PRIVATE SANITARY SEWER IMPROVEMENTS

to serve Coleman Company Addition Lot 2

Private Project Number
1280 PPS (607861)

AS-BUILT 10-16-02 AEG

C LINE 1

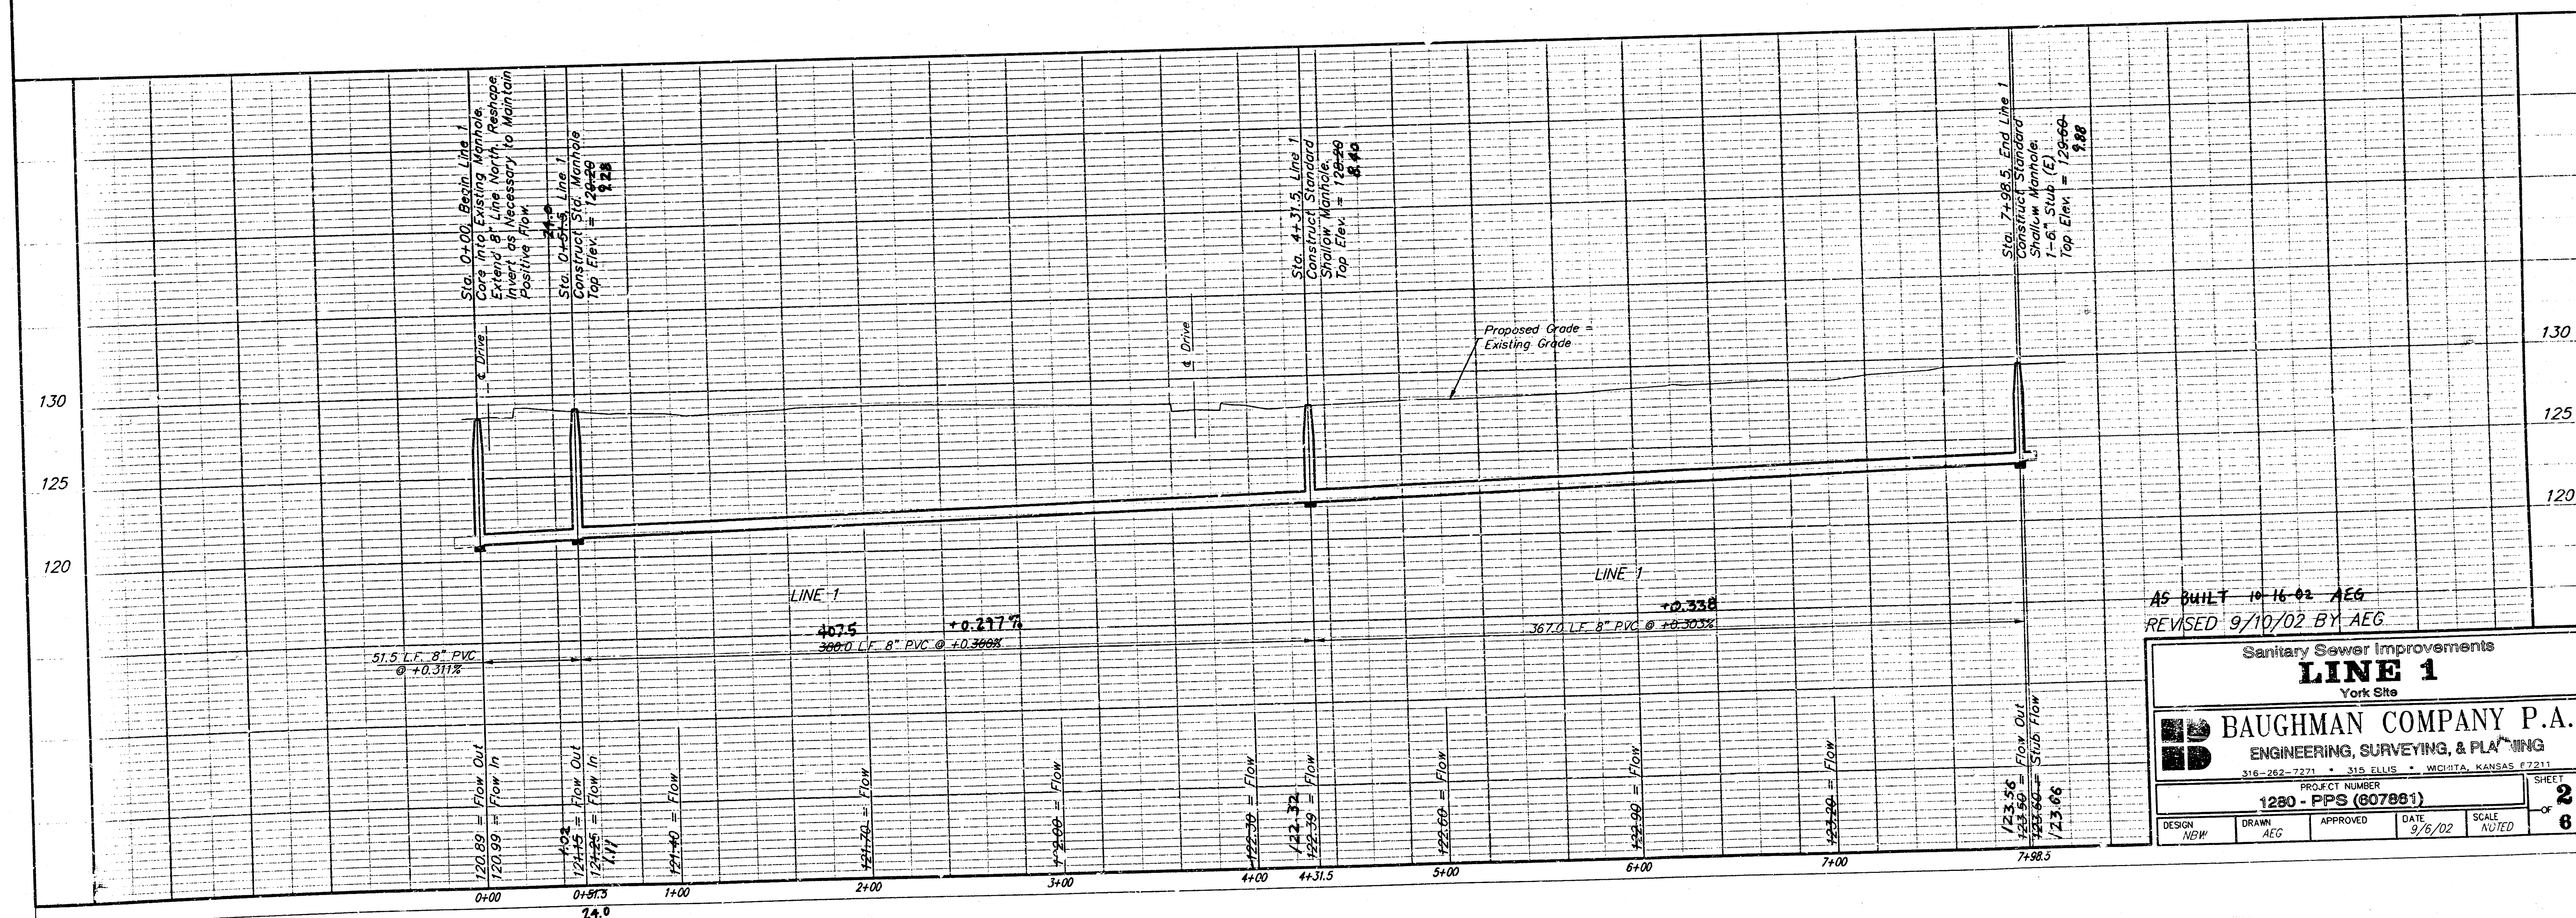
AS-BUILT NOTE: MH RELOCATED TO STA
0+24.0 TO AVOID U/G
GAS LINE CONFLI..
